ADDENDUM 1

ADDENDUM DATE: November 05, 2024

PROJECT: Onslow County Senior Services Center Renovation
4024 Richlands Highway
Jacksonville, NC 28540

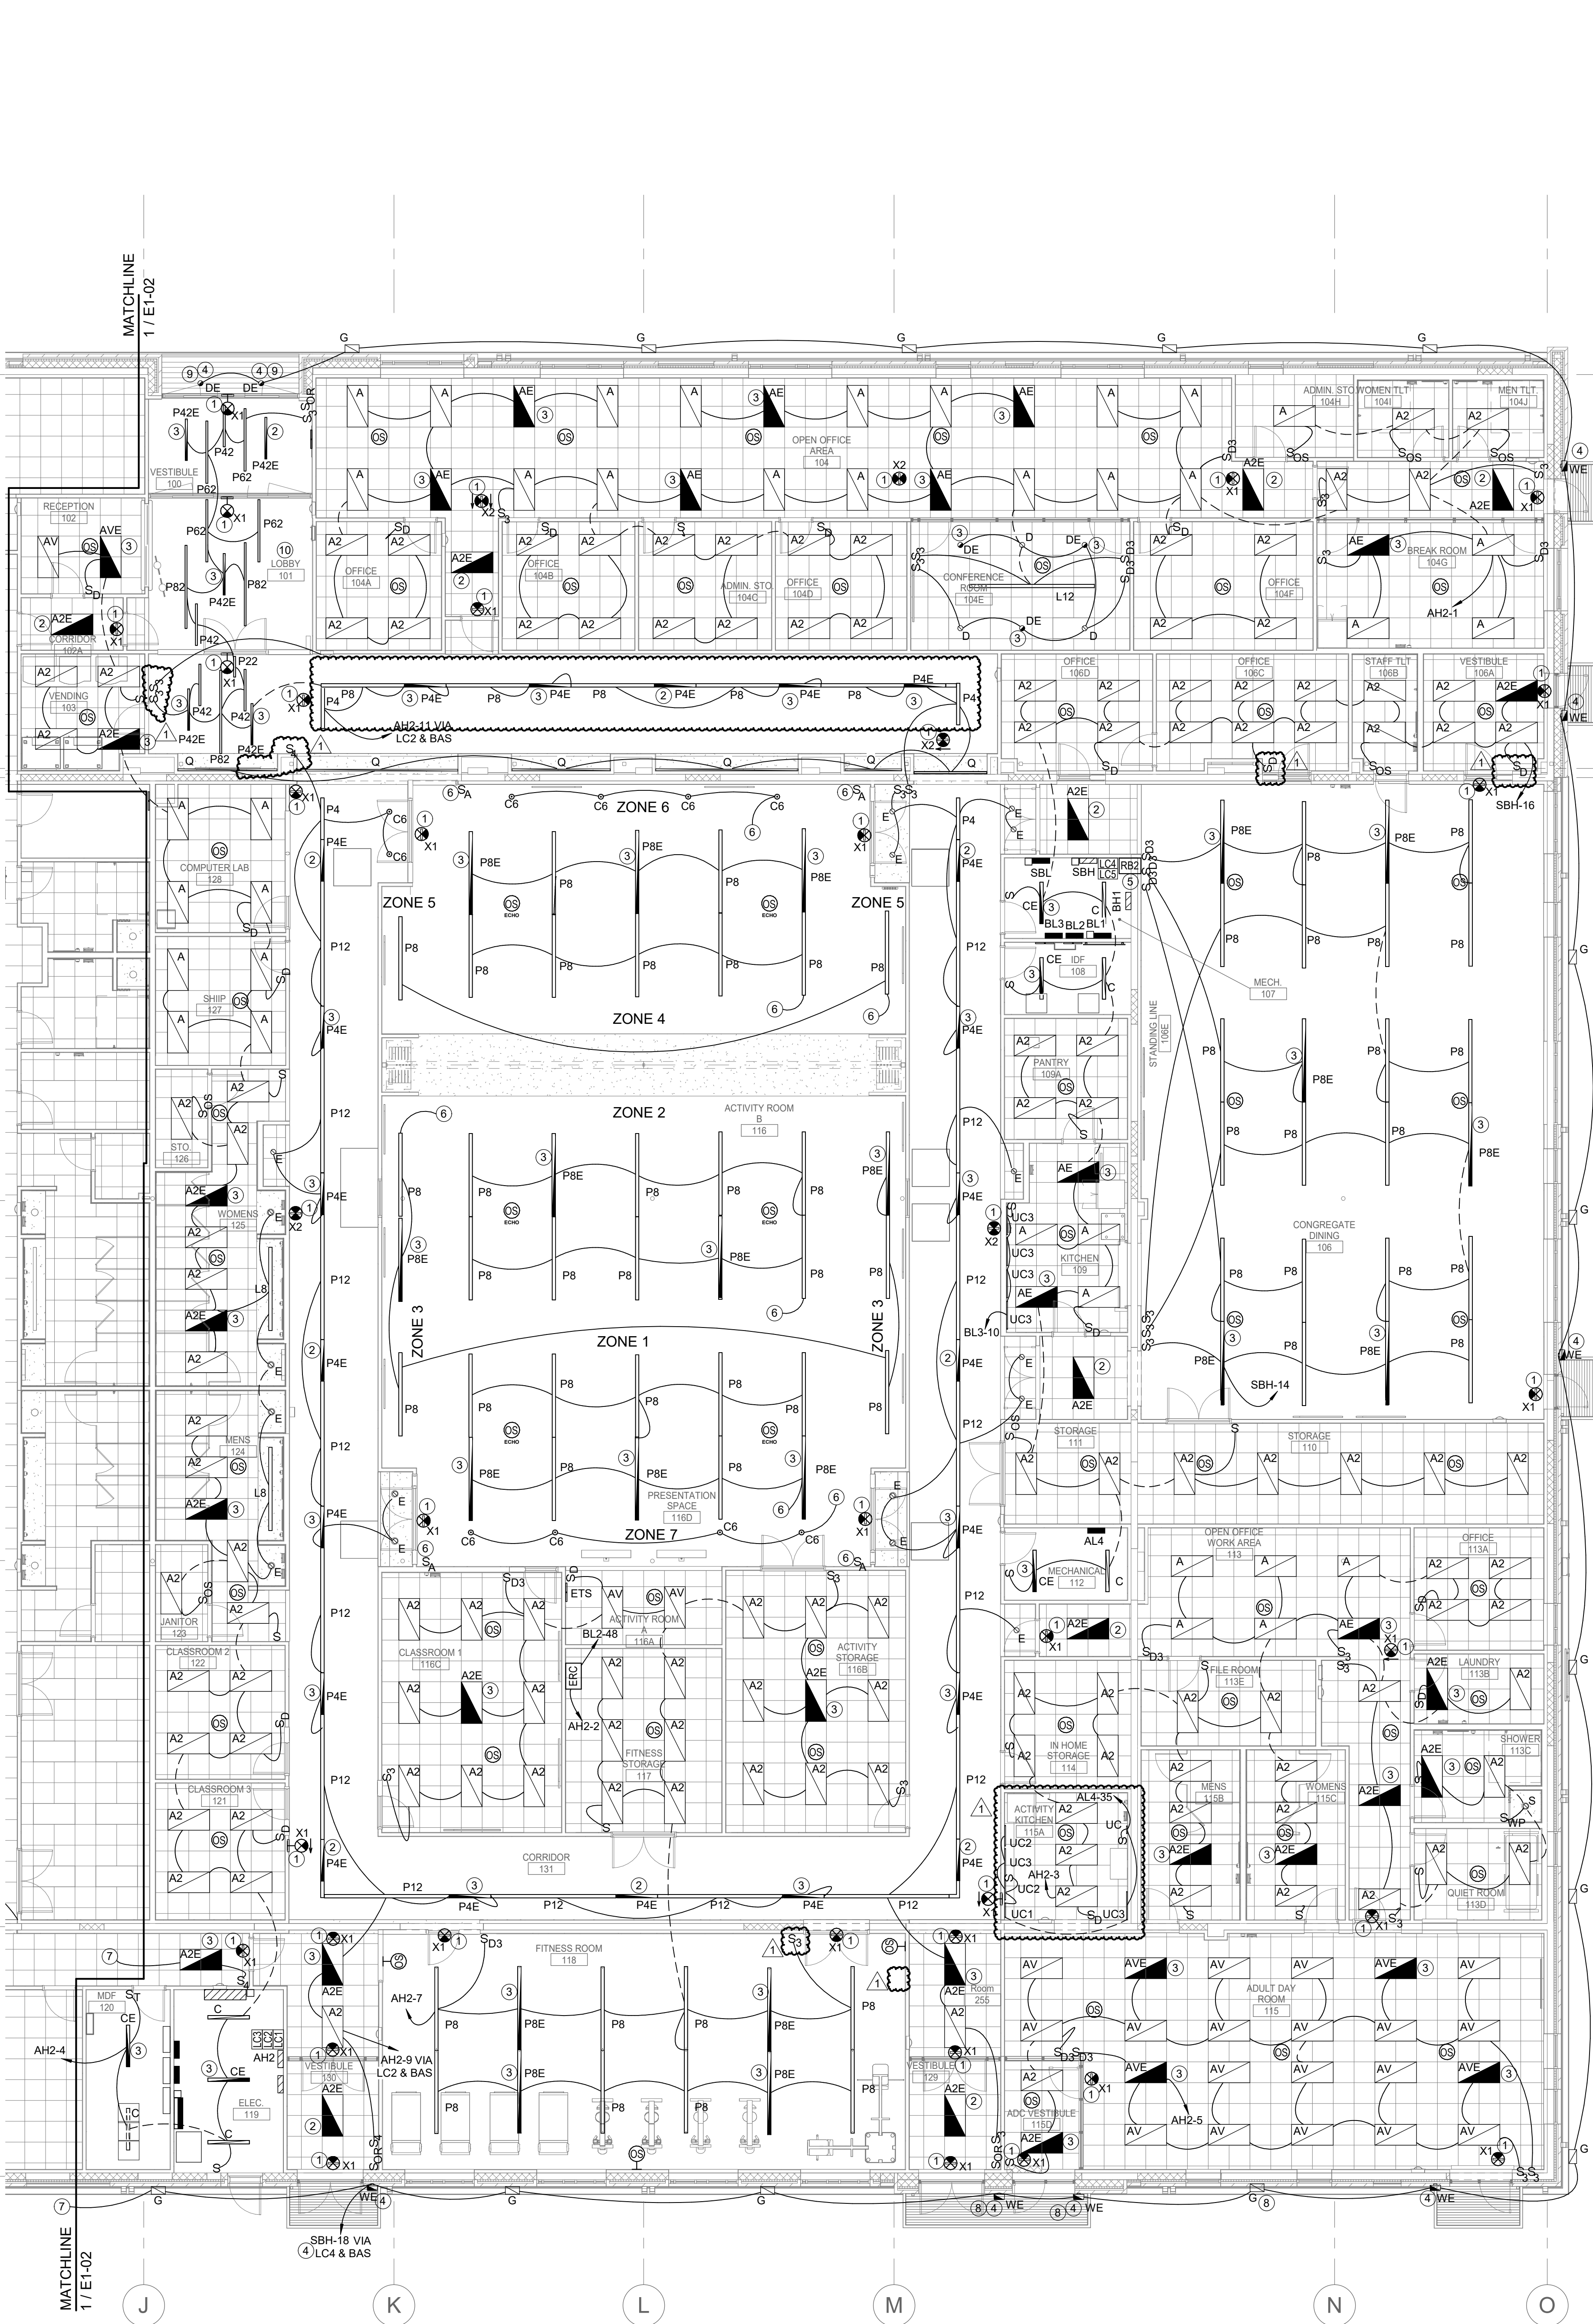
- Item 36 Sheet E1-01: REPLACE the sheet in its entirety with the attached sheet E1-01.
Note the following revisions:
- Added: Undercounter light fixtures at Room 115A.

- Revised: Light switch locations at various areas to avoid interferences. Shifted light fixture continuous linear run at corridor.
- Item 37 Sheet E1-02: REPLACE the sheet in its entirety with the attached sheet E1-02.
Note the following revisions:

1. Drawing E1-01
 - a. Added: Undercounter light fixtures at Room 115A.
 - b. Revised: Light switch locations at various areas to avoid interferences. Shifted light fixture continuous linear run at corridor.

1 POWER SITE PLAN
1" = 30'-0"

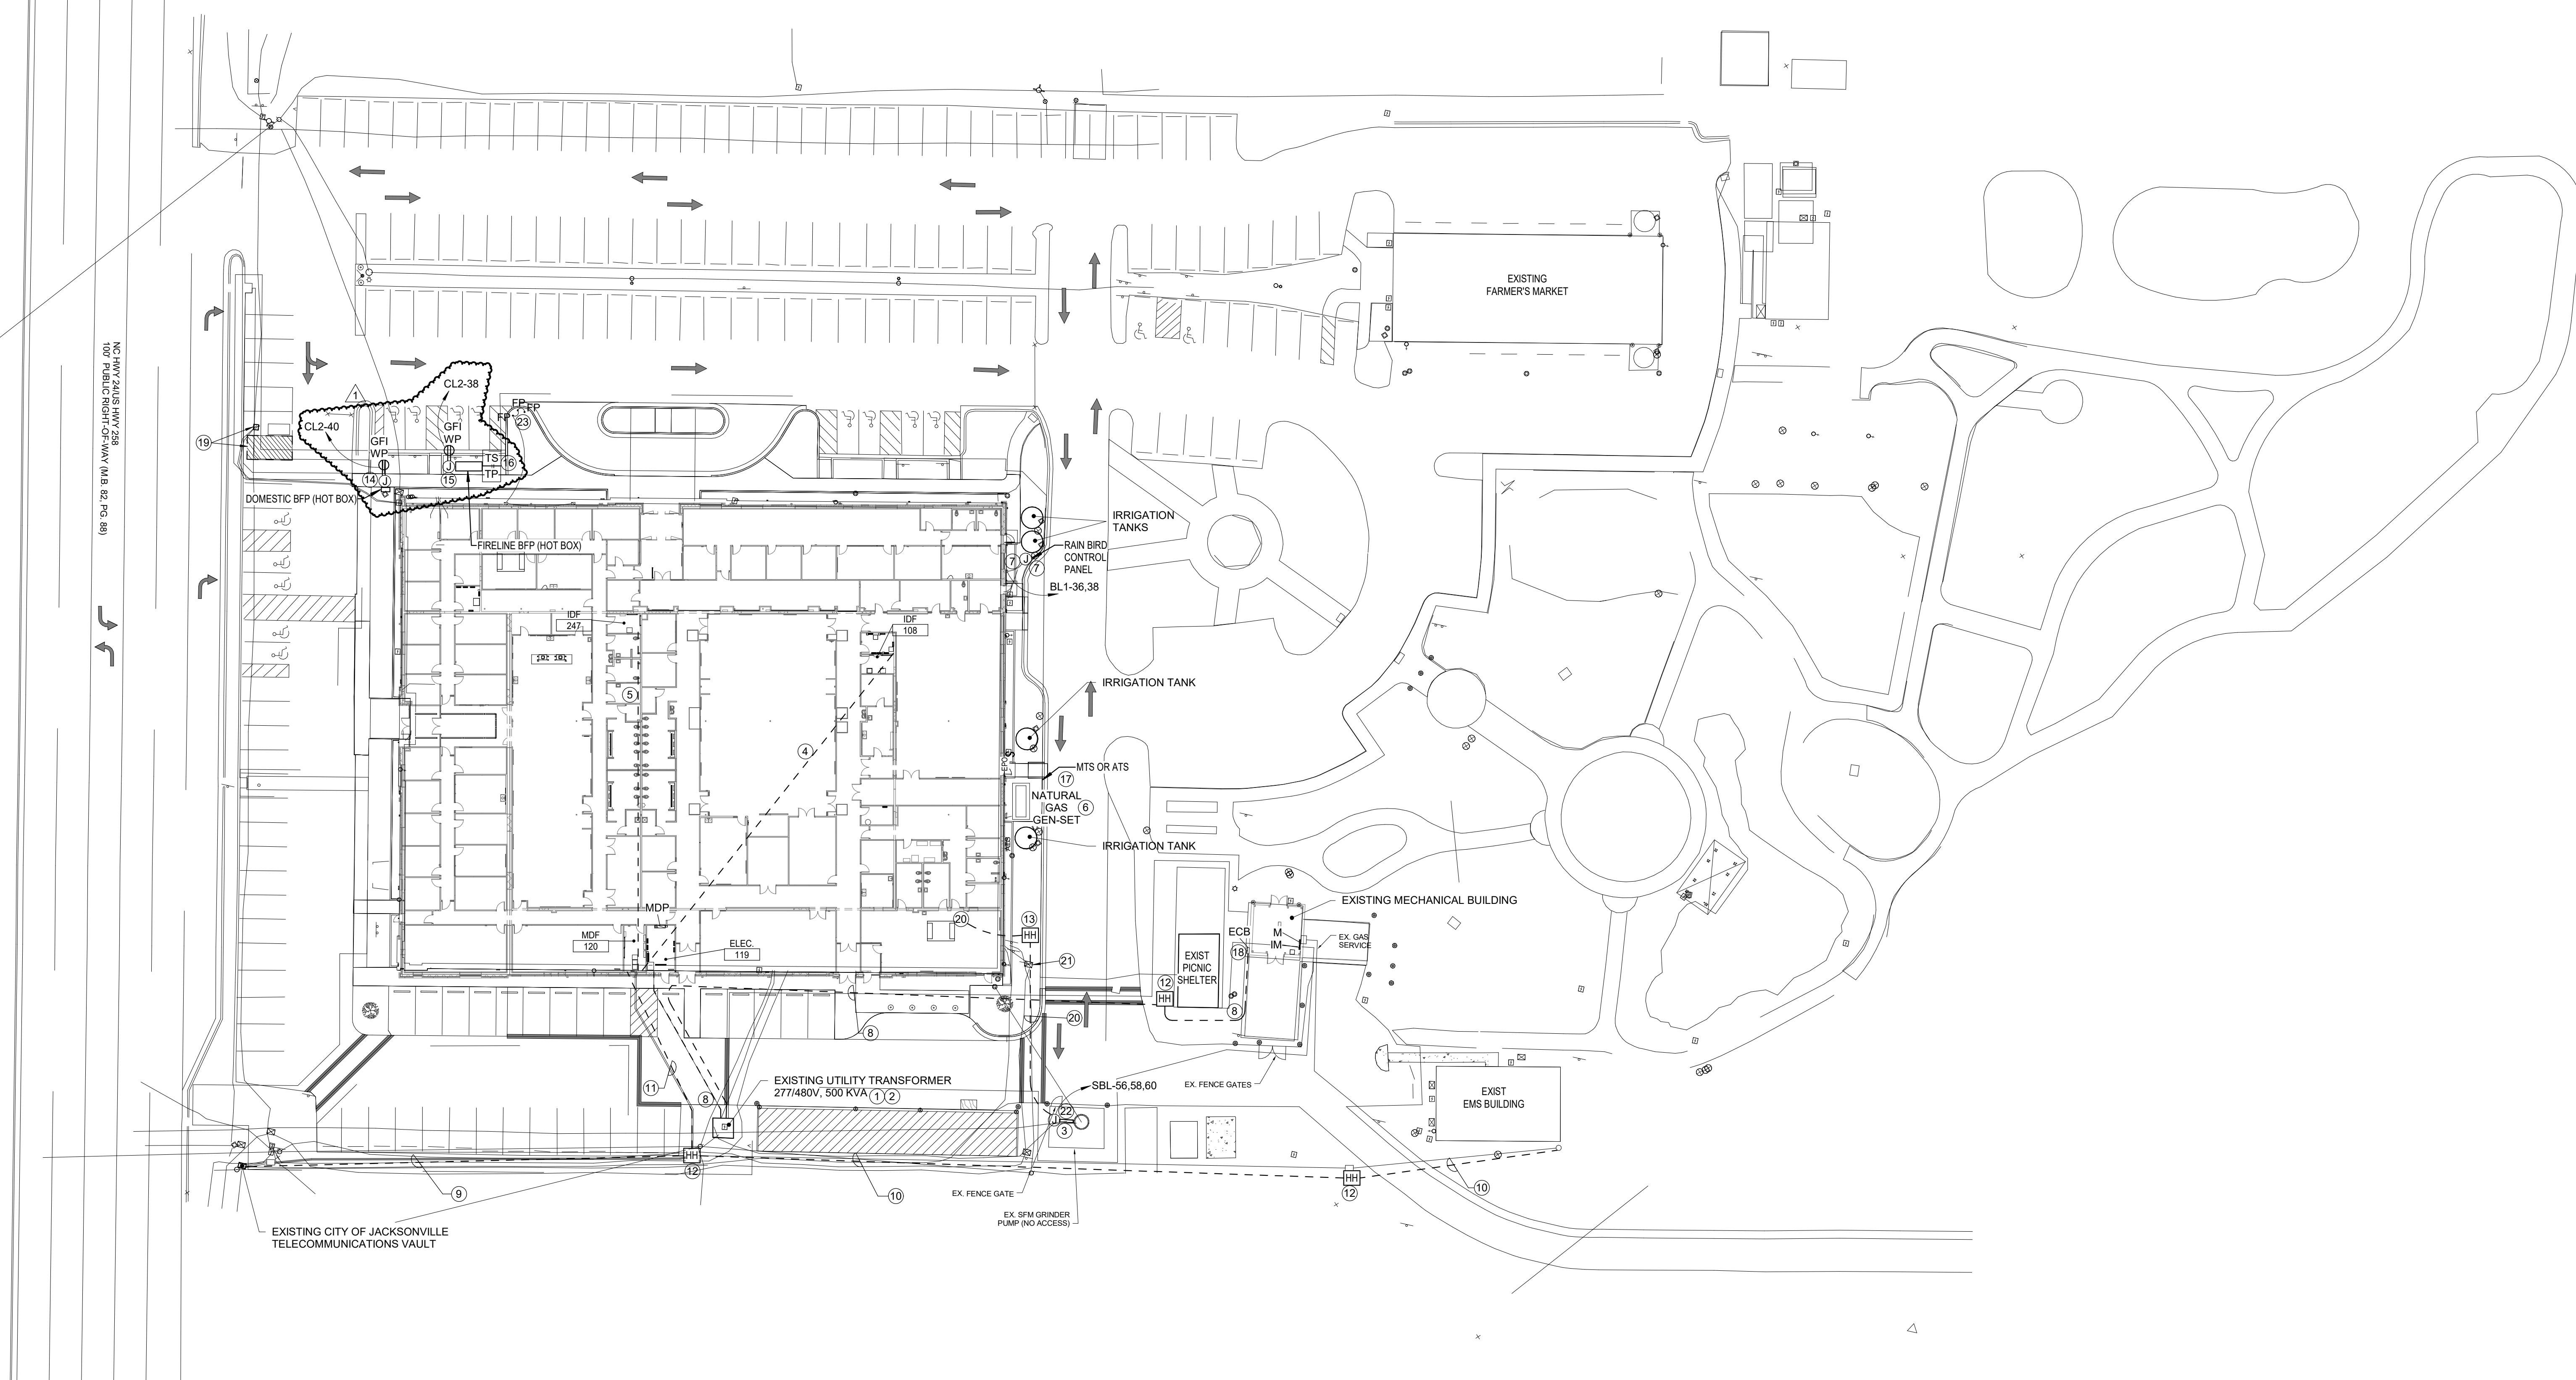
- Item 43 Sheet E6-01: REPLACE the sheet in its entirety with the attached sheet E6-01.
Note the following revisions:
- Revised Panel Schedules MDP, AL4.
- Item 44 Sheet E6-02: REPLACE the sheet in its entirety with the attached sheet E6-02.
Note the following revisions:
- Revised Panel Schedule CL2.
- Item 45 Sheet E6-03: REPLACE the sheet in its entirety with the attached sheet E6-03.
Note the following revisions:
- Added: Light Fixture Types CL2, CL3, CL4 and CL8.
 - Revised: Light Fixture Type UC3.
- Item 46 Sheet E7-01: REPLACE the sheet in its entirety with the attached sheet E7-01.
Note the following revisions:
- Revised Domestic and Fireline Hotbox locations and associated power and fire alarm conduit, wiring and devices to match civil drawings.

8. Drawing E6-01
 - a. Revised Panel Schedules MDP, AL4.
9. Drawing E6-02
 - a. Revised Panel Schedule CL2.
10. Drawing E6-03
 - a. Added: Light Fixture Types CL2, CL3, CL4 and CL8.
 - b. Revised: Light Fixture Type UC3.
11. Drawing E7-01
 - a. Revised Domestic and Fireline Hotbox locations and associated power and fire alarm conduit, wiring and devices to match civil drawings.
